Access Compliance Report
Public Rights-of-Way
(Curb Ramps)

Intersection ID: 8276	**Main Street: BROOKSHIRE_BV**	**Cross Street: N_LINWOOD_AV**	**Location: NE**
ADA ID: C554A5EA2A9D	**Ramp Type: Para**	**Initial Pass/Fail: Fail** **Overall Compliance: No**	**Severity Score: 13.75**

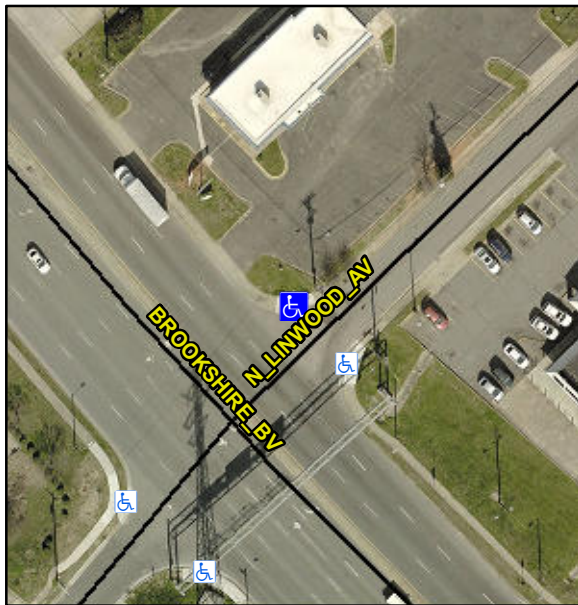
LT RP < 5%

R304.5.3, R304.3.2

Remove & Replace Entire Ramp.
